August 13, 2018

**RE: New England Clean Energy Connect Project
Update to NRPA and Site Law Applications**

In response to a number of agency data requests, CMP committed to providing additional updates and supplemental materials to the Site Location of Development Act (Site Law) and Natural Resources Protection Act (NRPA) permit applications for the New England Clean Energy Connect (NECEC) Project. In addition, CMP is providing updates to its applications associated with cultural resource identification, the Project design, Project impacts, and compensation. CMP has summarized these items below.

Figure 5.6.2
(Revised)
CMP NECEC
Raven Farm Substation
Modeling Layout

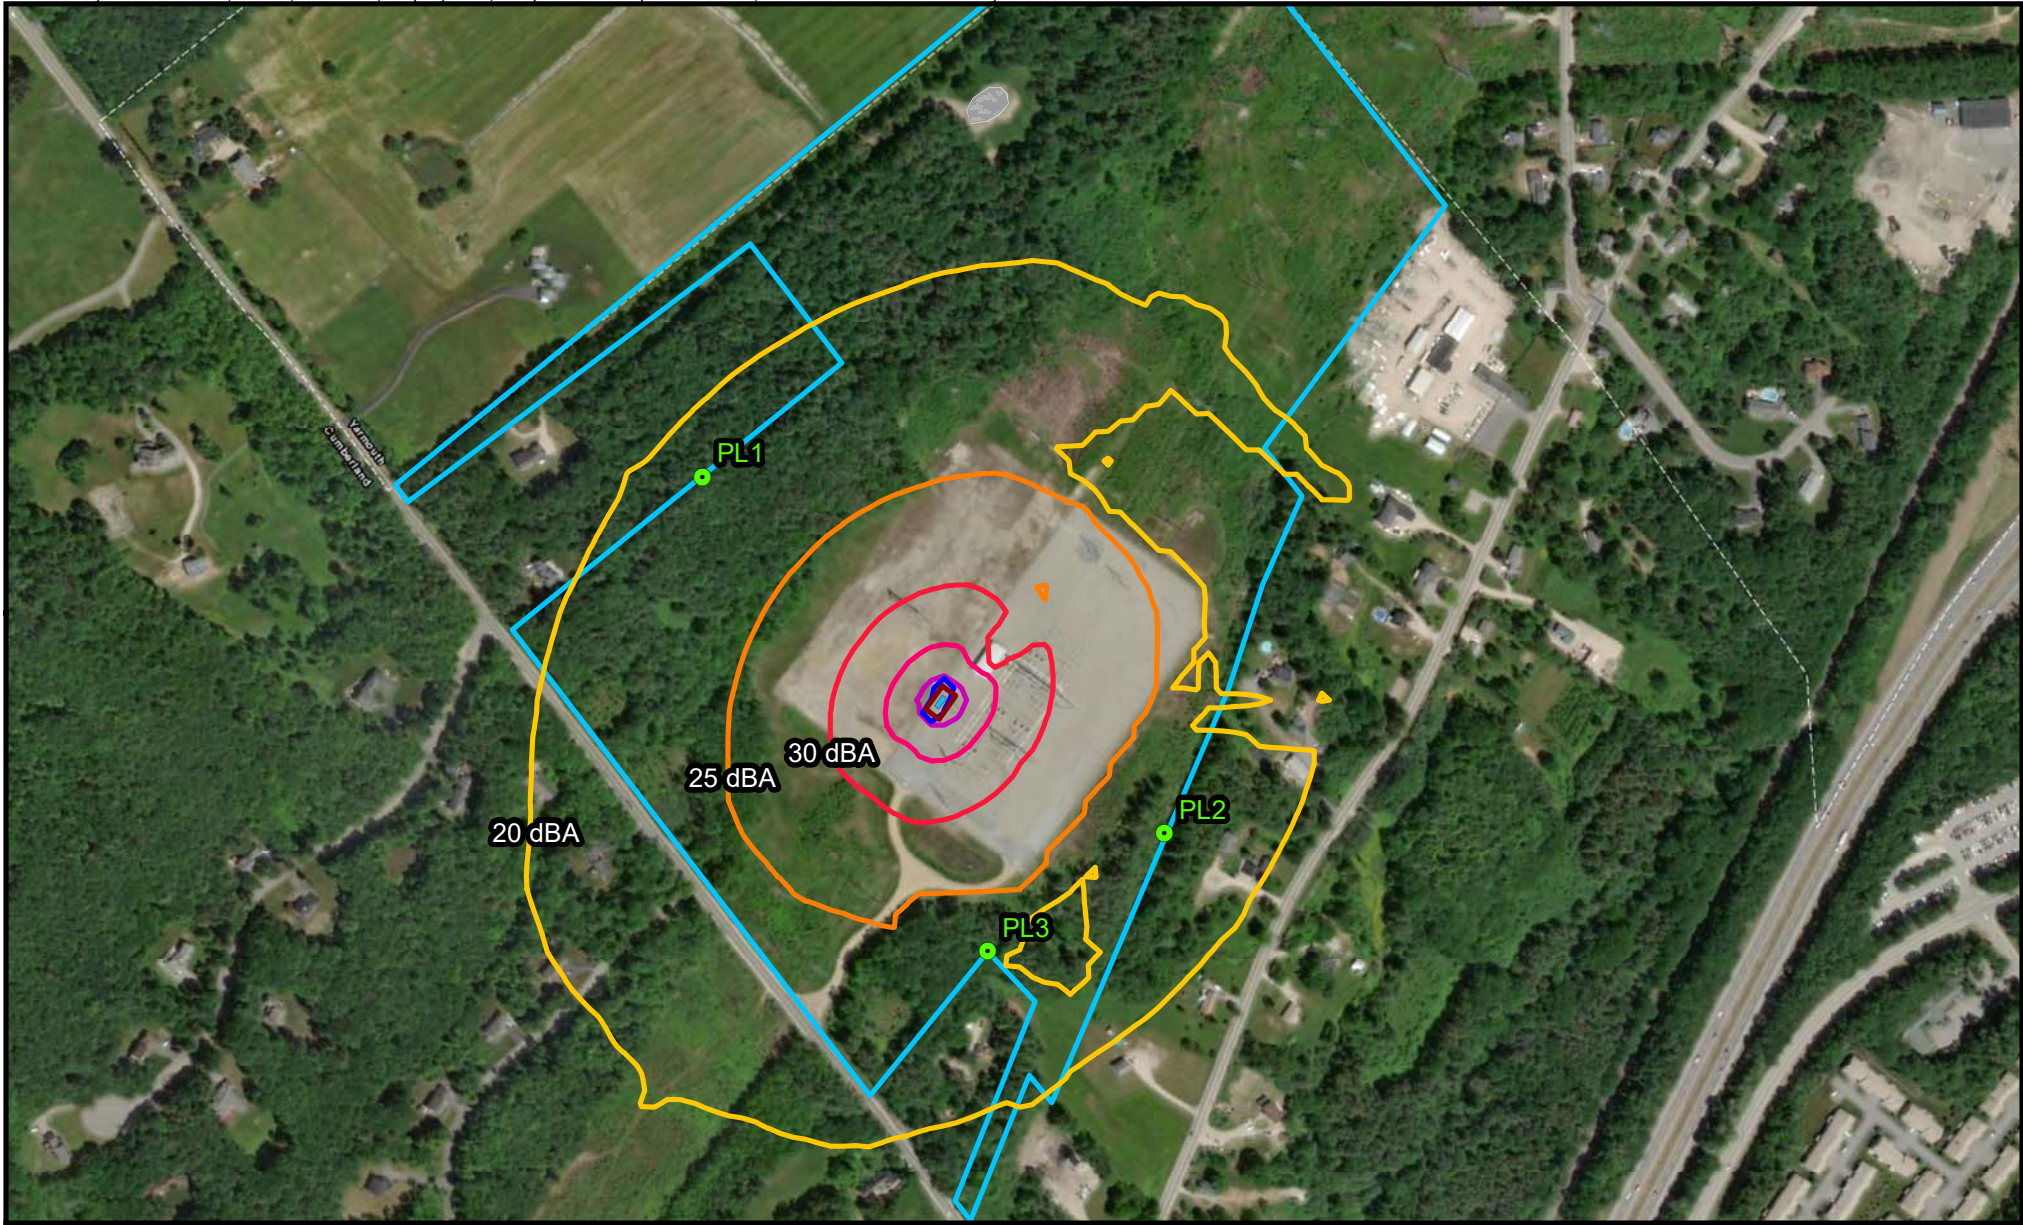
In July 2018, through meetings with the Town of Cumberland, Mitigation Option 3 was selected to be implemented at the substation. Mitigation Option 3 consists of a transformer rated at 65 dBA at 6 feet and a sound wall installed on all four sides of the transformer.

Figures 5.6.2 and 5.6.3 of the Site Law application should be replaced with the revised figures and Table 5-21 provided below.
